RE: SUB 2004-84 -- One-Step Final Plat of Eastside Community Church Second Addition

RE: SUB 2004-84 -- One-Step Final Plat of Eastside Community Church Second Addition

STAFF REPORT

CASE NUMBER: SUB 2004-84 -- EASTSIDE COMMUNITY CHURCH SECOND ADDITION

VICINITY MAP

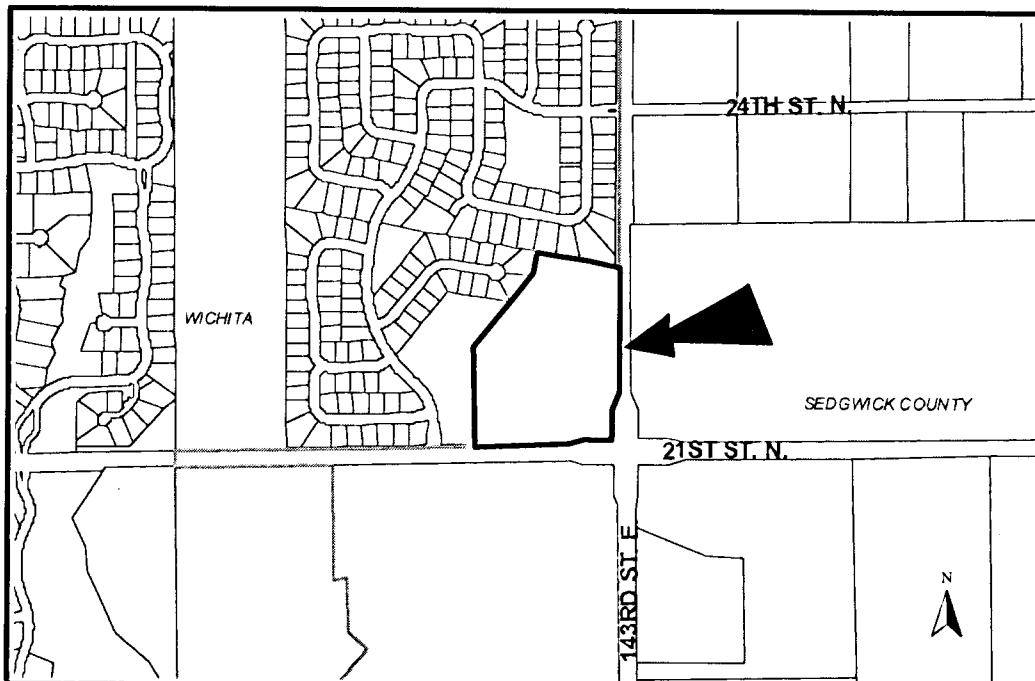
- E. The vicinity map needs revised to correctly reference 143rd Street.
- F. Traffic Engineering needs to comment on the access controls. The plat proposes one opening along both arterial streets. *The access controls are approved.*
